FIELD CHANGE ORDER	NUMBER: DS-630Q1-F001
--------------------	-----------------------

PROBLEM & SYMPTOM: Cross-talk problem between Dispatcher cable and switched cable. Revision incompatibility problem between M7764-00 and M7763-00 module  
(See Page 3 for more details)

FCO DS-630Q1-F001

INTERCONNECTION OF MIRA MODULES (SYSTEM A only is shown)

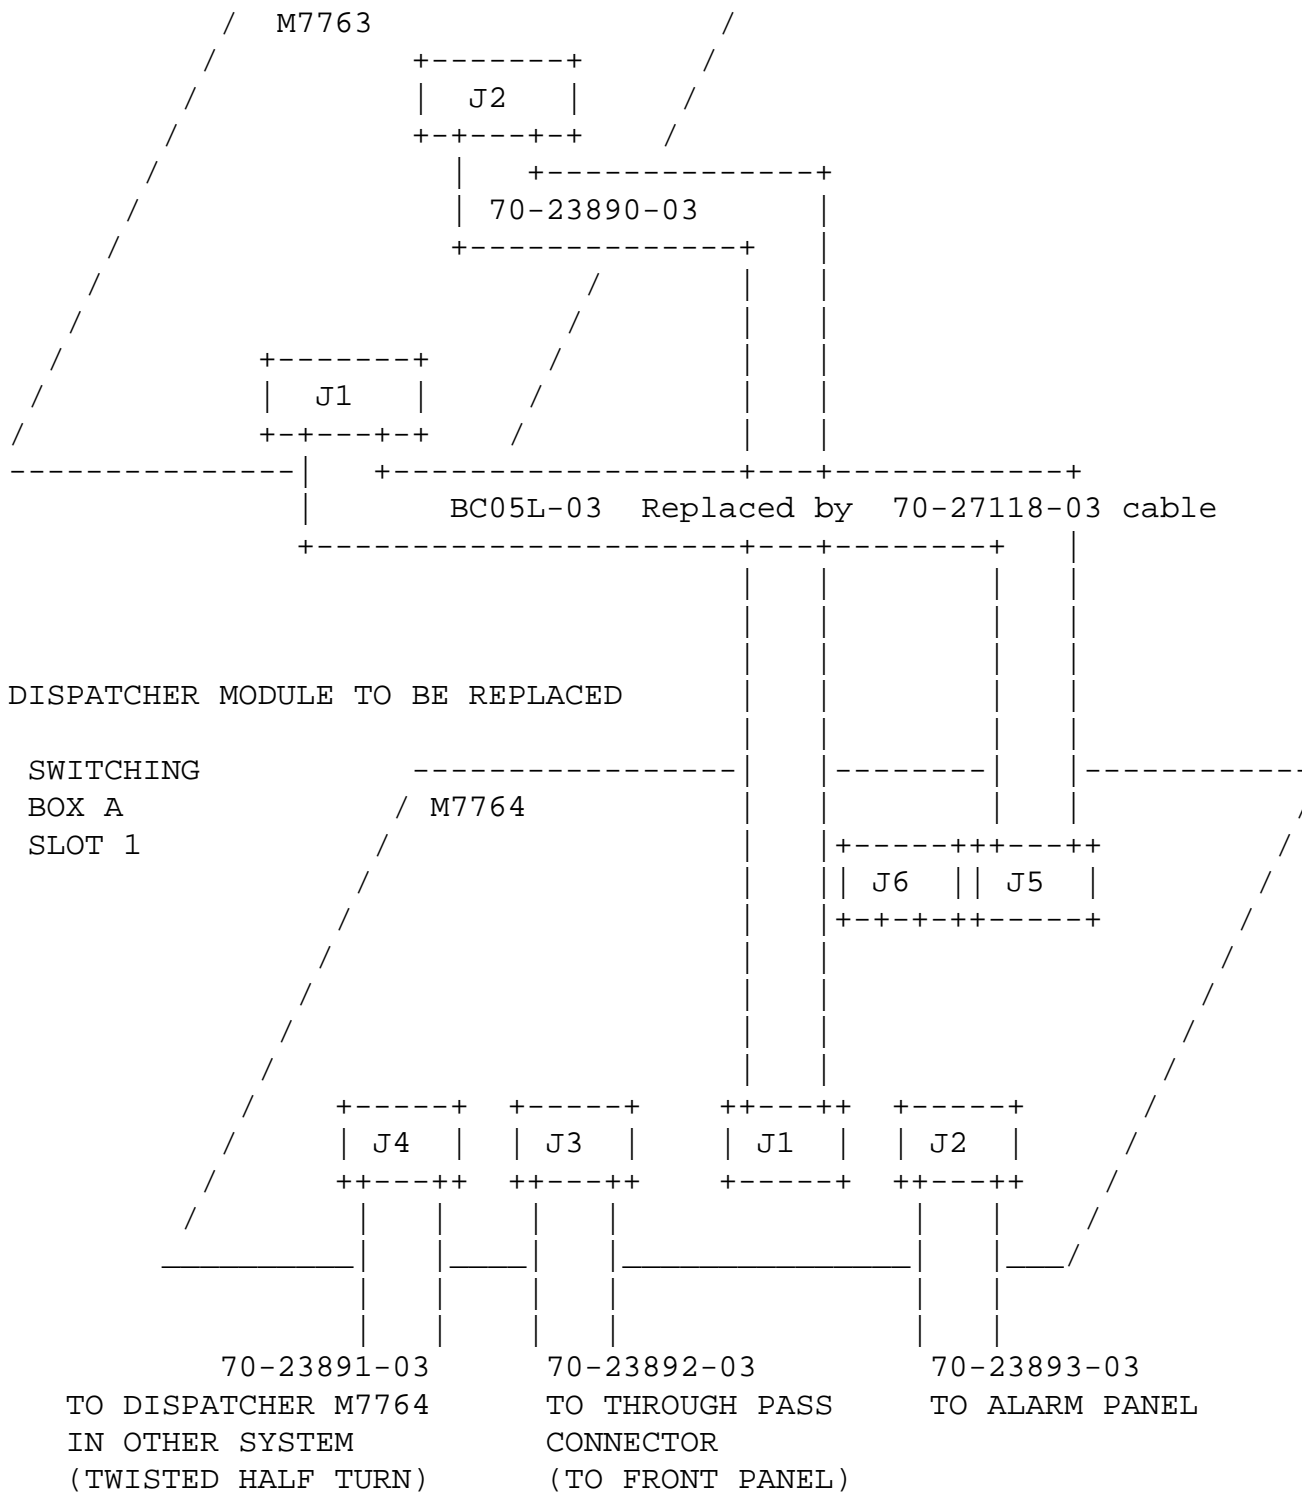
Intermittent data corruptions happen when testing switched KMV1A with MDM Diagnostics in MIRA Systems. The data was corrupted by cross-talk between cables generated by the BC05L cable between the MIRA watch-dog module (M7763-00) and the dispatcher module (M7764-00).

A re-layout of the two modules M7763-00 and M7764-00 has been necessary to adapt the impedances between these modules. Both M7764 and M7763 become Revision E with the new etch. A new cable 70-27118 has been designed to replace the BC05L cable.

WATCH DOG MODULE TO BE REPLACED

The interconnection of the modules and cables to be replaced is shown on Page 4.

Replace all modules M7763 and M7764 at Revision D or below by new modules at Rev E and replace BC05L dispatcher cables at one time.

14. Take the new module M7763-00 at Rev. E, and reconnect the cable 70-23890-03 (20 pins) into connector J2.
15. Connect the new round cable (3 feet) 70-27118-03 into J1 of the M7763 module. (note mark connector upper side)

22. Replace the BC05L-03 cable from the M7763-00 by the round cable (3 feet) 70-27118-03. Connect it to J5 (right hand side) of the M7764 module. Note that J5 and J6 locations can vary on previous revisions modules (A, B, C or D).
